SUBJECT: James A. FitzPatrick Nuclear Power Plant
Docket No. 50-333
**Request for Additional Information -
Proposed Changes to the Technical Specifications
Spent Fuel Pool Storage Capacity (JPTS 90-035)**

**RESPONSE TO NRC REQUEST 2 FOR ADDITIONAL INFORMATION
SPENT FUEL POOL STORAGE CAPACITY INCREASE**

HOLTEC REPORT HI-91614
DYNARACK SIMULATIONS TO DEMONSTRATE THE ABILITY
TO PREDICT CLASSICAL NONLINEAR PHENOMENA

FIGURE 2.14

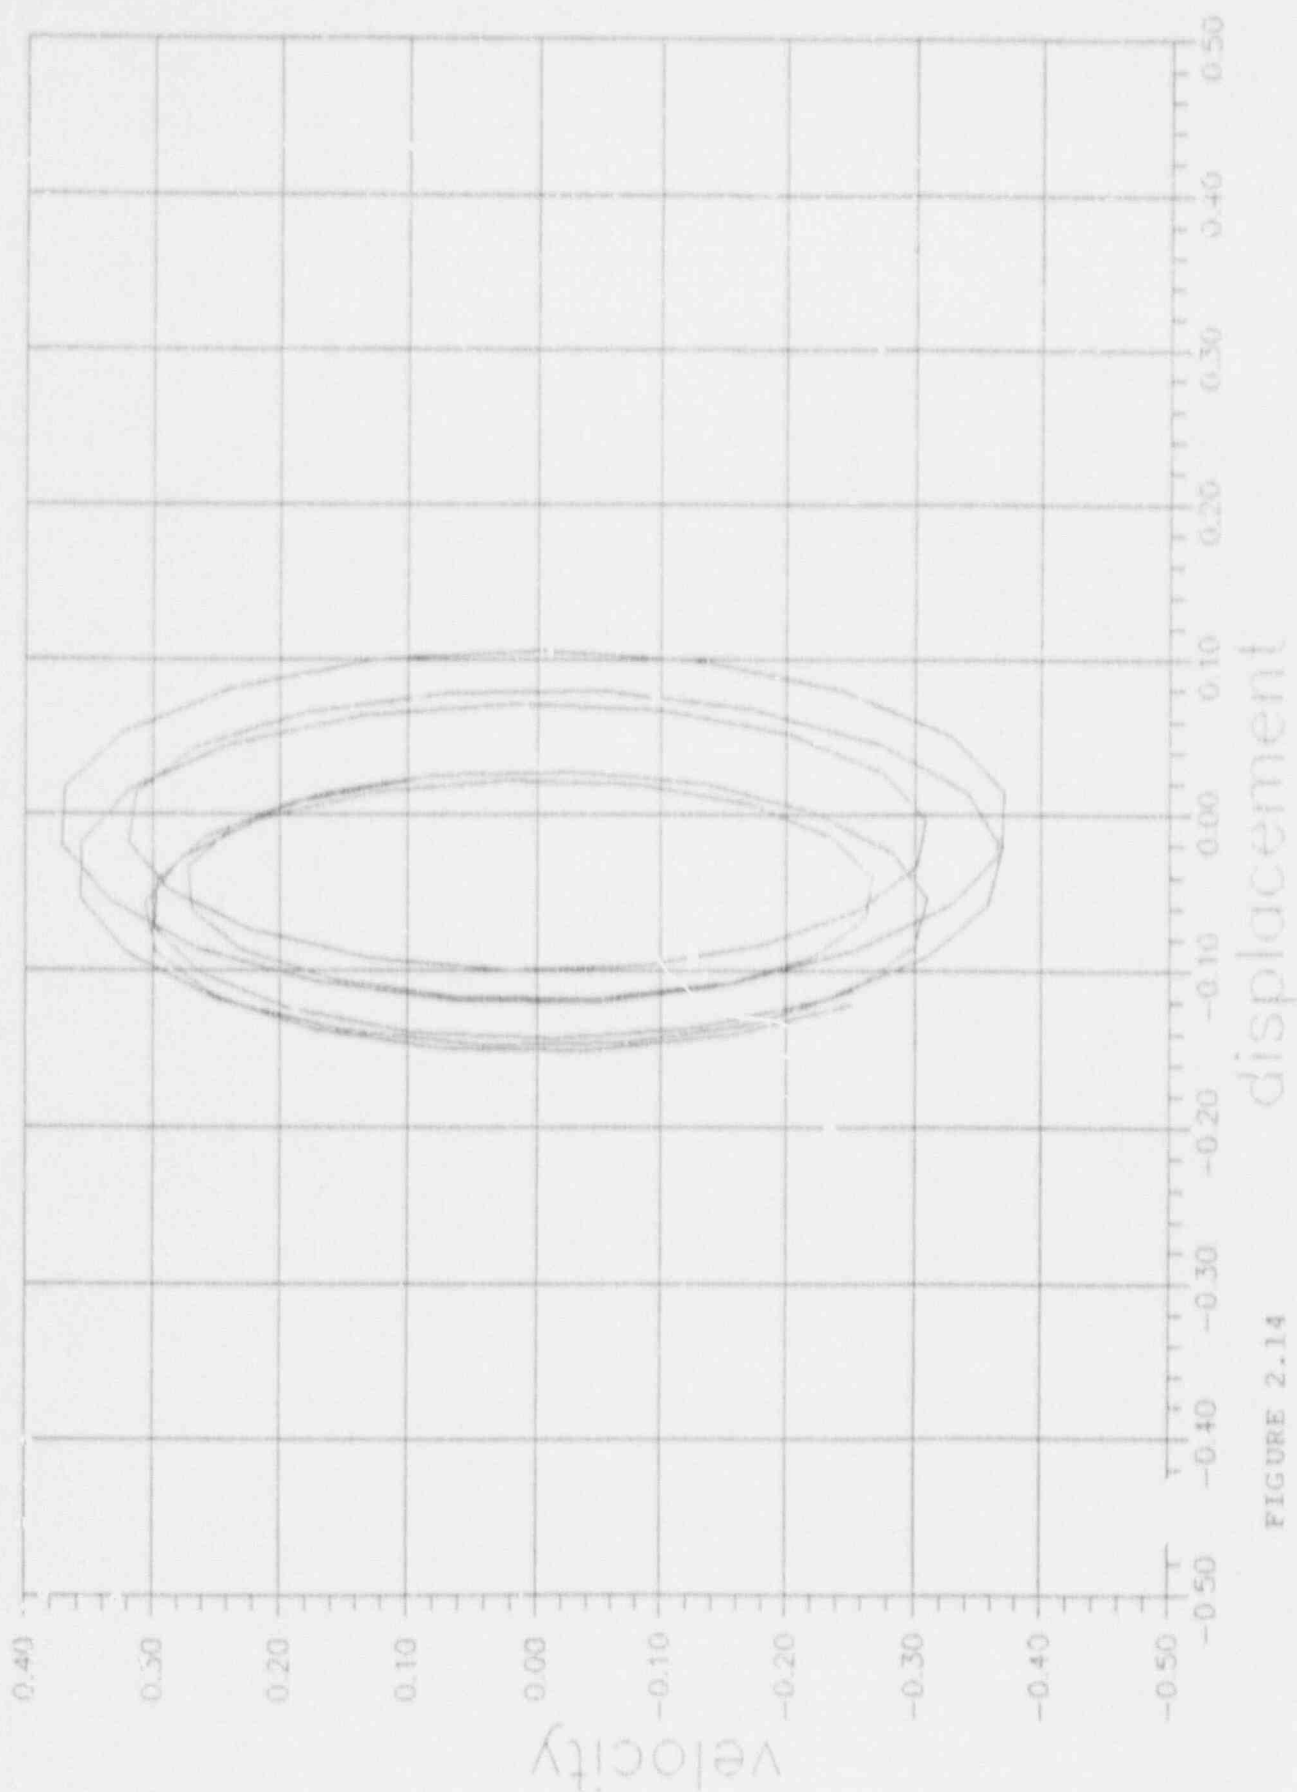
P. 6-15. It is stated that a central difference scheme is used for solution of the governing differential equations. Demonstrate how such a scheme can adequately depict various response phenomena, such as, subharmonic, bifurcation, and instability associated with nonlinear dynamics. Provide a specific example for such demonstration similar to that provided in references (1) and (2). Discuss how error associated with numerical integration is assessed and accounted for in a similar manner as that of reference (3). Also provide verification of the computer results with available experimental data.

The results from DYNARACK, for the same problems of Figure 2.9, are shown in Figures 2.10 - 2.14. The computer simulation started from a specified initial condition and covered a sufficient number of cycles so that a limit cycle could be established. Figures 2.10 and 2.11 show the match with two problems shown in Figure 2.9. The simulation predicts the one or two stable limit cycles. Figures 2.12 - 2.14 show results of the similar analysis for the third case considered. Figures 2.12 and 2.13 show the effect of different starting conditions. It is clear that only the stable period one orbit is being tracked by the numerical solution. Figure 2.14 is a plot of only the last few hundred time steps and confirms the tendency toward the stable period one orbit. The period three orbit appears unstable which seems to contradict the conclusion in Shaw and Holmes. However, if one reads the text in Figure 2.9, Shaw and Holmes appear to conclude that an unstable period three also exists at the same parameter values. We can only conclude that it is extremely fortuitous if the numerical solution can simulate a stable orbit when an unstable orbit with the same period exists concurrently.
